# Access Compliance Report

## Public Rights-of-Way

### (Curb Ramps)

Intersection ID: 29724	Main Street: FALLS_LAKE_DR	Cross Street: LANNIER_FALLS_LN	Location: SE
ADA ID: 8B506263CB30	Ramp Type: BlendTrans1	Initial Pass/Fail: Fail	Overall Compliance: No
Severity Score: 8.75			
Codes/Mitigation Info/Possible Solution		Field Measurements/Component Compliance

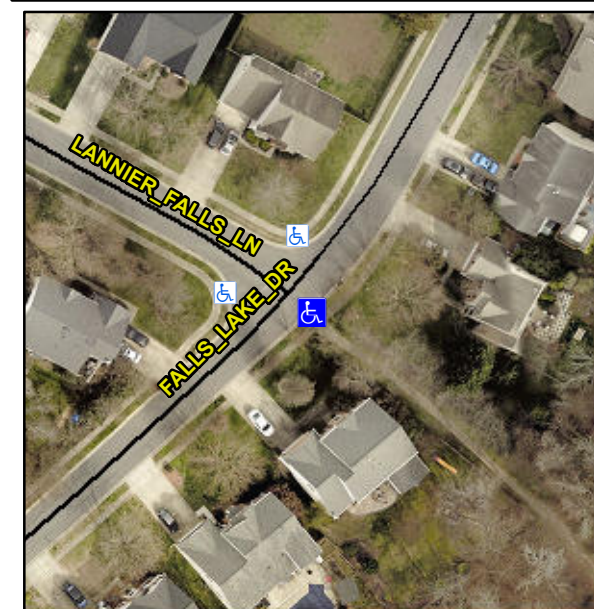
**R304.5.1**

Compliance	Description	Data	Compliance	Description	Data
N/A	Ramp Length (in)	43.0	Yes	BlendTrans Slope (%)	4.6
No	Ramp Width (in)	47.0	Yes	BlendTrans XSlope (%)	1.6
N/A	Flare Type LT	N/A	N/A	Flare Type RT	N/A
N/A	Flare Slope LT (%)	N/A	N/A	Flare Slope RT (%)	N/A
N/A	Flare Traversable LT?	N/A	N/A	Flare Traversable RT?	N/A
N/A	Landing Length (in)	N/A	N/A	DWS Provided?	N/A
N/A	Landing Width (in)	N/A	N/A	DWS Contrast?	N/A
N/A	Landing Slope (%)	N/A	N/A	DWS Length (in)	N/A
N/A	Landing X Slope (%)	N/A	N/A	DWS Full Width?	N/A
N/A	Landing Curb? (Y/N)	N/A	N/A	DWS Offset (in)	N/A
N/A	Shared Landing?	N/A			
N/A	Gutter Ponding?	N/A	N/A	Gutter Slope (%)	N/A
N/A	Gutter Lip Ht (in)	N/A	N/A	Gutter X Slope (%)	N/A
N/A	Painted X Walk1?	No	N/A	Painted X Walk2?	N/A
	X Walk 1 Direction	To NW		X Walk 2 Direction	N/A
	X Walk 1 Width (in)	N/A		X Walk 2 Width (in)	N/A
	X Walk 1 Slope (%)	1.1		X Walk 2 Slope (%)	N/A
	X Walk 1 X Slope (%)	0.8		X Walk 2 X Slope (%)	N/A

**Remove & Replace Curb Ramp With Two New Directional Ramps or Equivalent.**
